REPLACEMENT PARTS FOR A VCT-U14 TRIPOD ADAPTOR

13 Sep 1996

Product: **DXC-537AP, DXC-537P, DXC-537PM, DXC-637P, DXC-M7P, PVW-637P, UVW-100P, UVW-200P, VCT-U14**

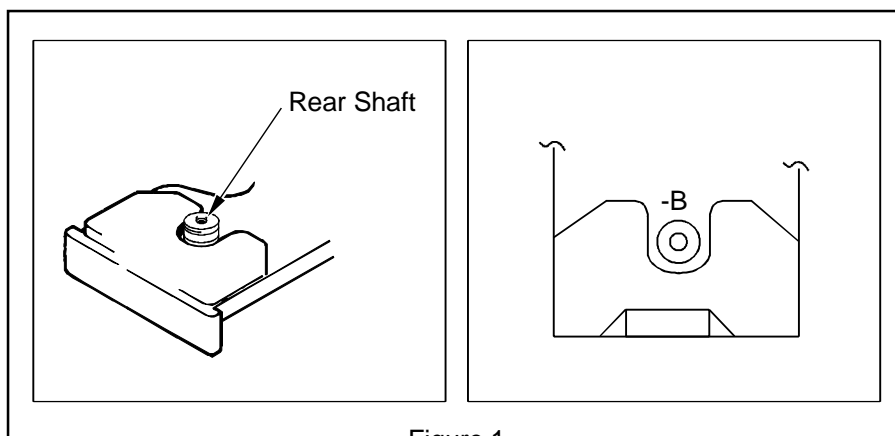
Refer to Figure 1. When repairing a VCT-U14 tripod adaptor that has the mark '-B' adjacent to the rear shaft, use the parts listed in Table 1.

Repair Item	Part Number	Recommended Replacements	Part Number	Notes
MOUNT	3-679-045-xx	MOUNT	3-679-045-05	Remove the REAR SHAFT
		SPRING B	3-679-056-02	
REAR SHAFT	3-679-043-01	MOUNT	3-679-045-05	
		SPRING B	3-679-056-02	
		REAR SHAFT	3-679-043-01	
BRACKET, UNC, SCREW	3-679-041-xx	MOUNT	3-679-045-05	Remove the SLIDER
		SPRING B	3-679-056-02	
		BRACKET, UNC, SCREW	3-679-041-03

Repair Item	Part Number	Recommended Replacements	Part Number	Notes
SLIDER	3-679-044-xx	MOUNT	3-679-045-05	Remove the BRACKET, UNC, SCREW
		SPRING B	3-679-056-02	
		BRACKET, UNC, SCREW	3-679-041-03	
		SLIDER	3-679-044-03	
BASE	3-679-040-xx	MOUNT	3-679-045-05	Remove the SLIDER
		SPRING B	3-679-056-02	
		BRACKET, UNC, SCREW	3-679-041-03	
		BASE	3-679-040-03	
LEVER	3-679-047-xx	LEVER	3-679-047-02	
		SPRING C	3-679-057-02
